RESS-8-9

# 8th RESS IG

# IMMA L6/L7 contribution

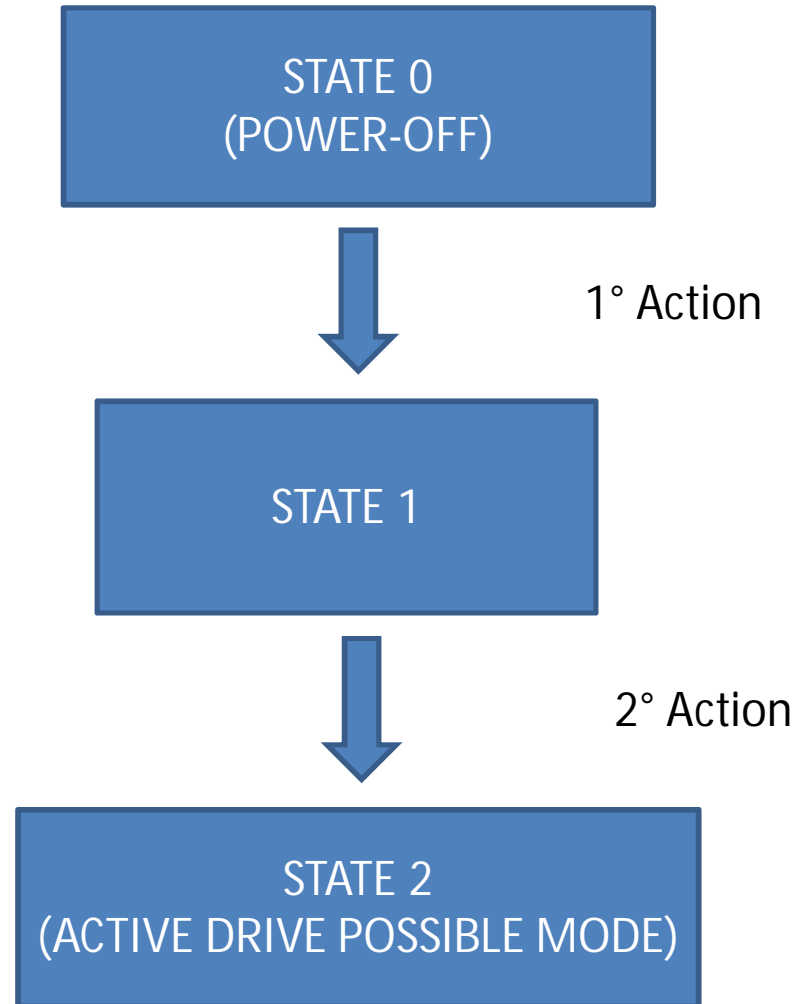
- 5.3 IMMA interpretation is that :
  1. if other alternative means are provided that ensure active driving possible mode is disabled when alighting the vehicle, this section should not apply.
  2. If an indicator for the active driving mode is present before the rider leaves the vehicle the requirement is satisfied.
  3. If the vehicle is on the central parking stand the wheel cannot touch the ground so is not in active possible driving mode,

IG RESS may consider additional language to confirm the above applicable for L-category vehicles.
